ADDENDUM NO. 9
TENDER NO. 54-21
DOUGALL AVENUE REHABILITATION –
OUELLETTE PLACE TO EUGENIE STREET WEST

March 23, 2021

600mm SQUARE TRAFFIC MANHOLE	DWN BY: EH	DWG. NO. TS - 10
	CHECKED BY: SB	
	DATE: DEC 2018	
	APPROVED BY:

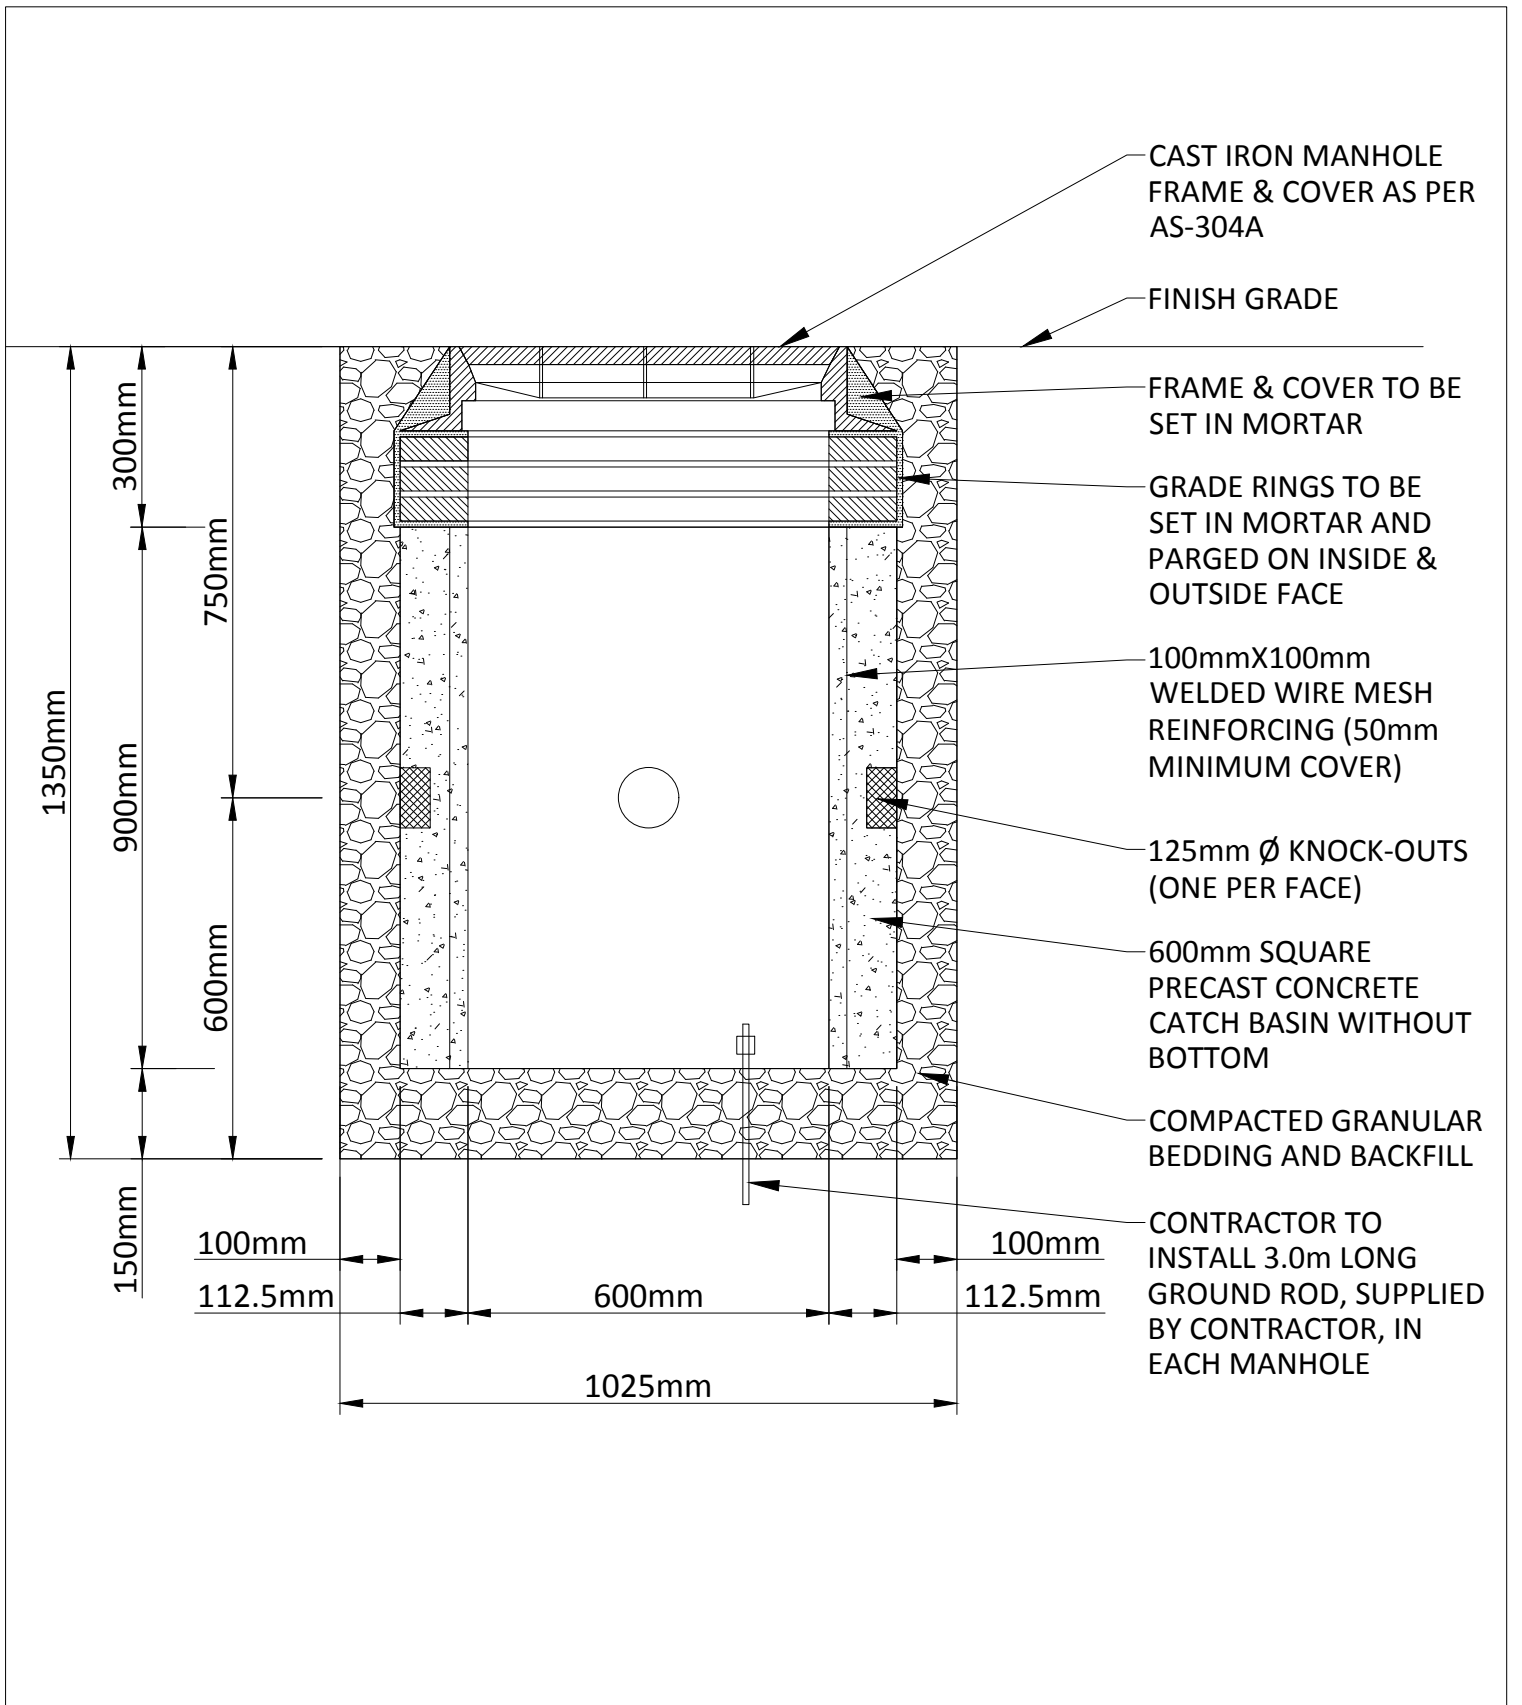
Item D11 600mm Traffic Manhole – Do you have detail for the 600mm Traffic Manhole? How deep is the manhole?

Answer: Attached.
